**PROJECT SCOPING PLAN FOR PERFORMING A CERCLA
REMEDIAL INVESTIGATION/FEASIBILITY STUDY (RI/FS) AT
BUILDING 804 AND THE ASSOCIATED RADIOACTIVE WASTE
BURIAL SITES (SEAD-12) AND THE MISCELLANEOUS
COMPONENTS BURIAL SITE (SEAD-63)**

**PROJECT SCOPING PLAN
REMEDIAL INVESTIGATION/FEASIBILITY STUDY
AT SEAD-12 & SEAD-63
SENECA ARMY DEPOT ACTIVITY
ROMULUS, NEW YORK**

**Parsons Engineering Science, Inc.
Prudential Center
Boston, Massachusetts**

FIGURE 4-1
PROPOSED SOIL GAS
SAMPLING LOCATIONS

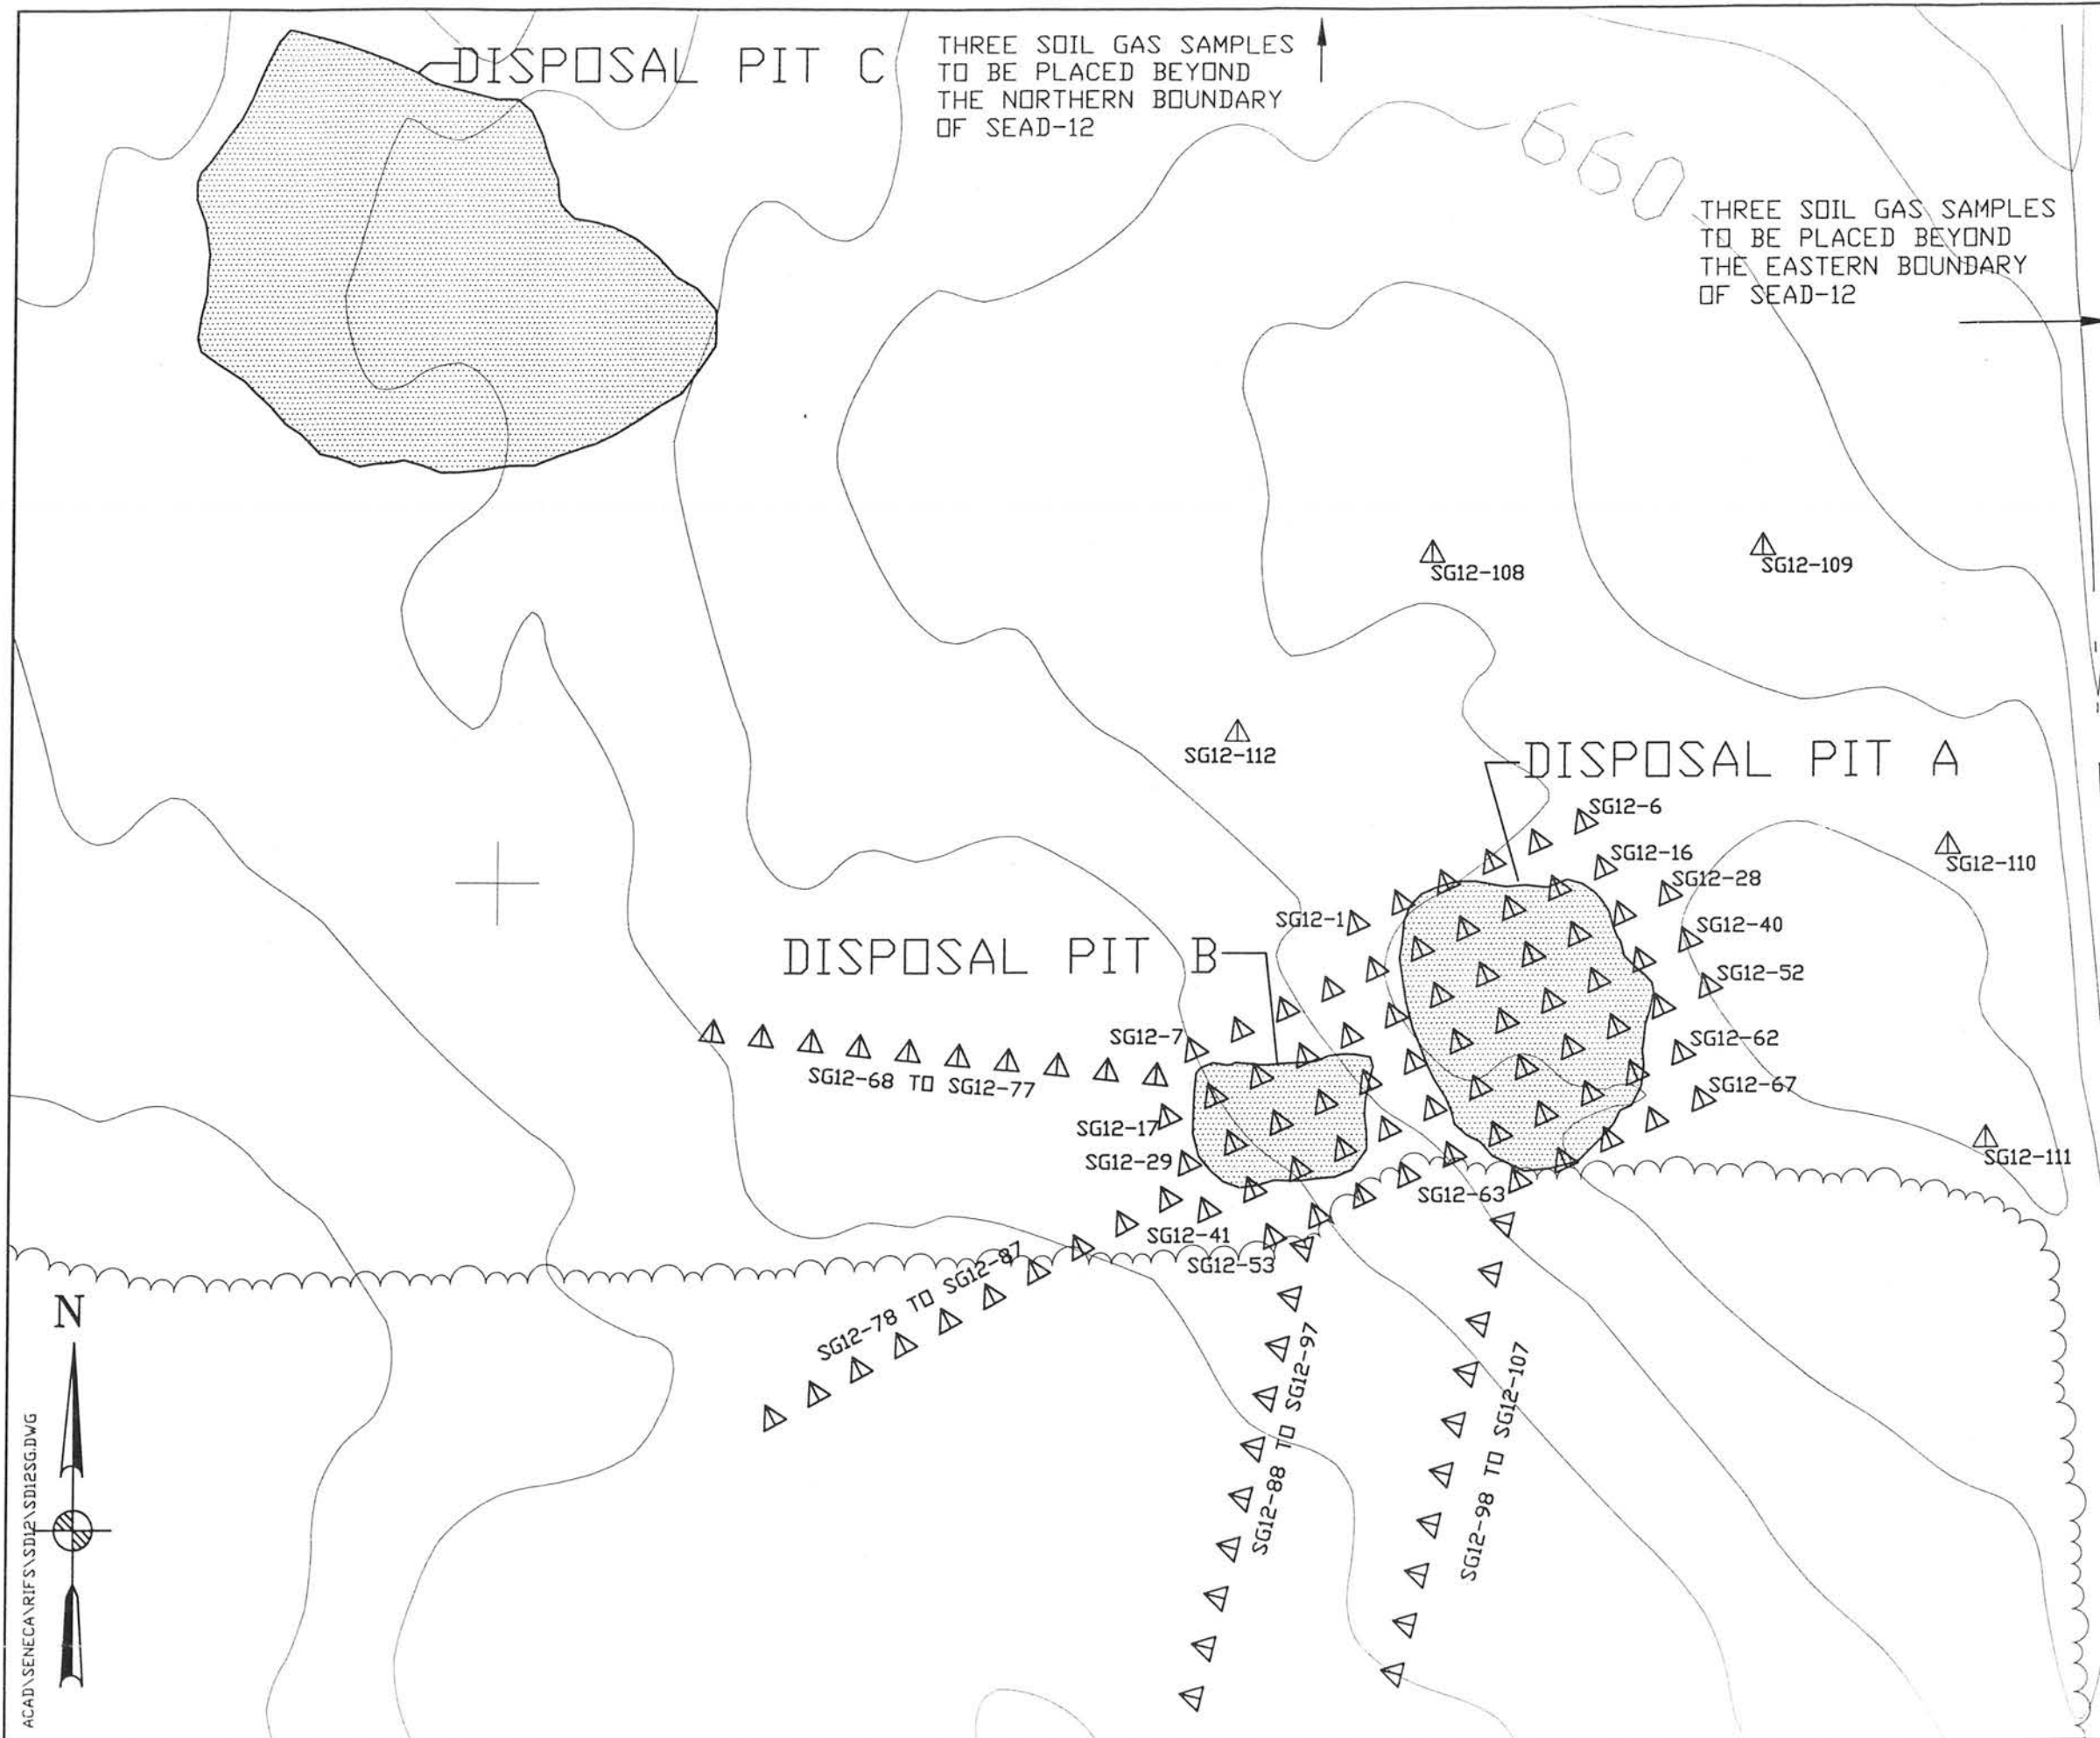
This section states that soil gas sample locations are shown in Figure 4-1. The locations are not shown on the legend of Figure 4-1. Using soil radon data to delineate a volume of soil contaminated with radium may not be the best approach since the radon emanation rate of the soil is unknown. Further, it is not likely that the radon emanation rate in the areas of concern are constant. The use of downhole gamma count rates to delineate contaminated areas should be considered. Estimate of Radium Contaminated Soil On Five Sites In Ottawa, Illinois, September-October 1988, prepared for the USEPA Region 5 (ANL/ESH/TS-89/100, March 1989), describes how this type of measurement may be used to estimate subsurface soil radium concentrations.

The text here should reference Plate 4-1 and Figure 4-1.

The soil gas sample locations are shown on the legend of Figure 4-1.

Response #25 Agreed. The text should reference Plate 4-1 and has been changed accordingly.

Figure 4-5
Radiological Survey Decision Tree
for
Buildings 800, 802, 803, 804, 805, 806, 810, 812, and 825

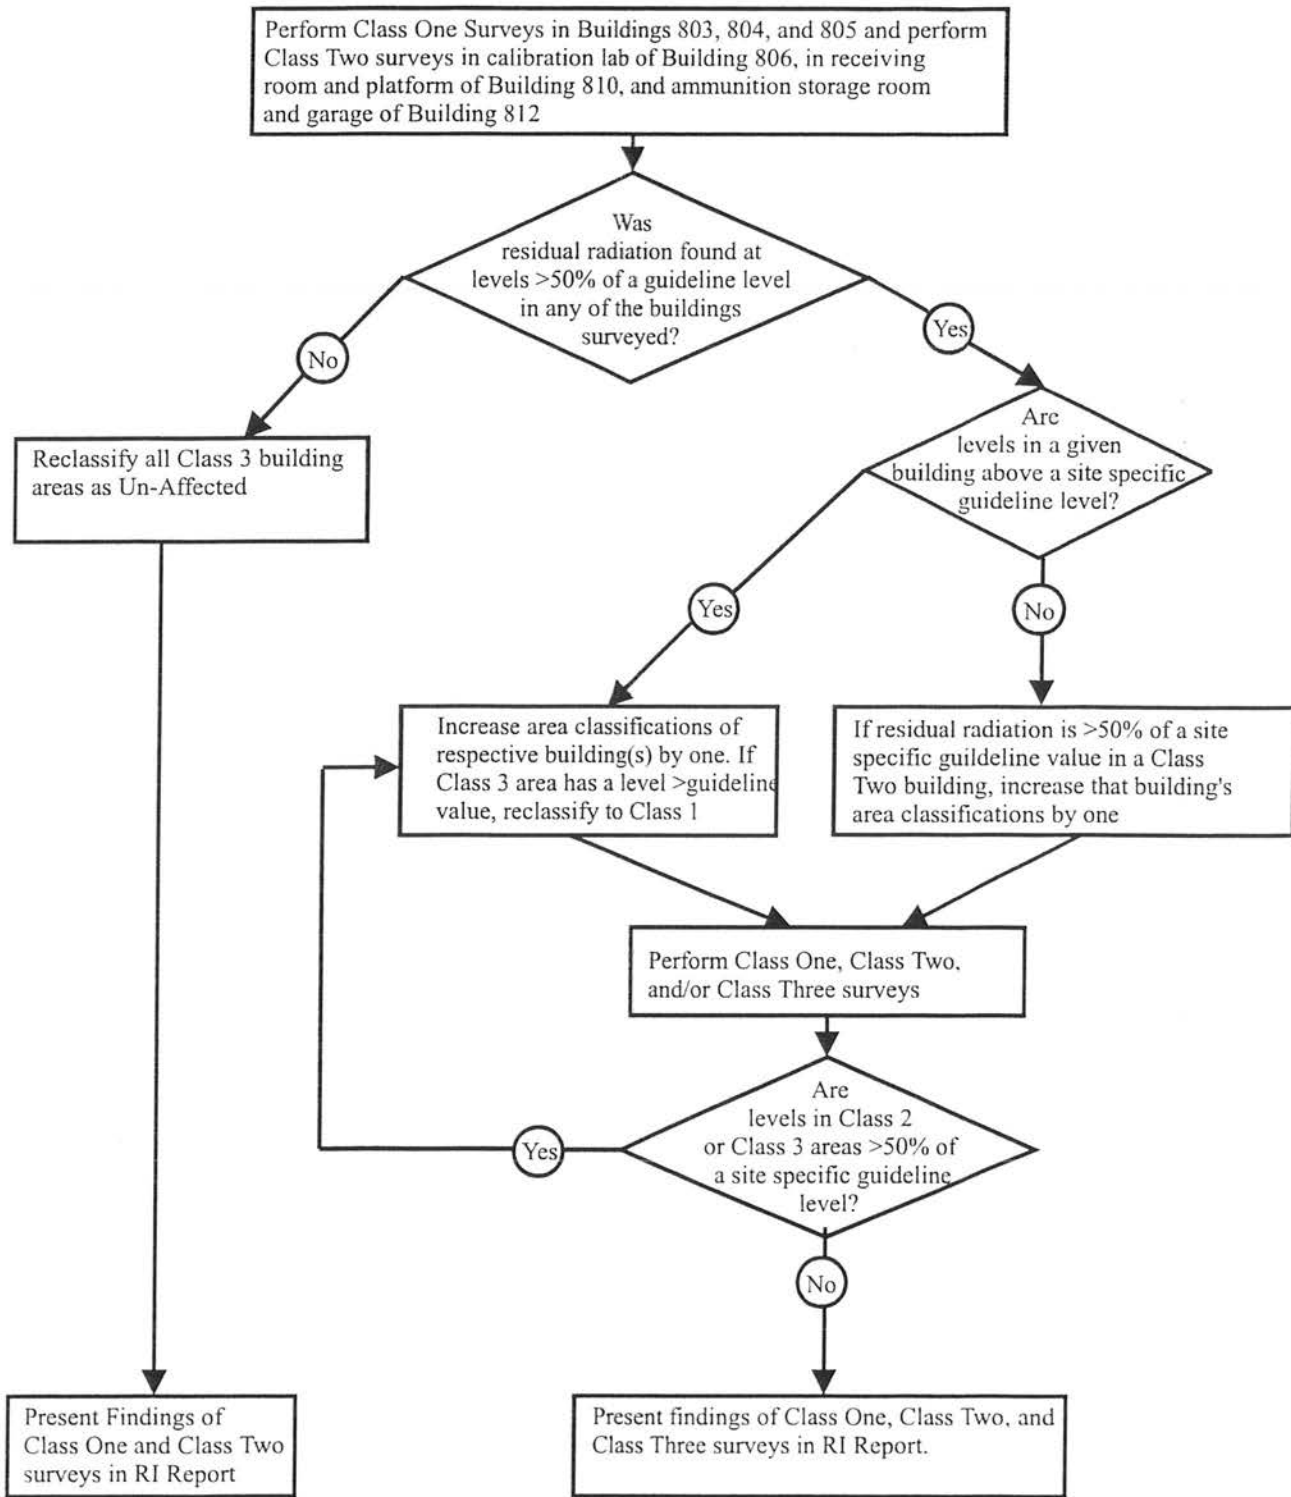
Comment #30 Figure 4-5:

Comment #34 Figure 4-5:

b) Further, for ecological purposes, gamma exposure rates should be taken as close to ground surface as possible (as opposed to the 3' referenced on page 4-9). Proposed surface soil samples for SEAD-12 (page 4-11) should undergo a full TCL organic and TAL inorganic analyses to determine what levels of contaminants may be present. Previous surface soil analyses indicated the presence of elevated levels of metals and PAHs. For SEAD-48 (page 4-35) the surface soil samples which will only be undergoing radioanalyses should be noted in Figure 4-5.
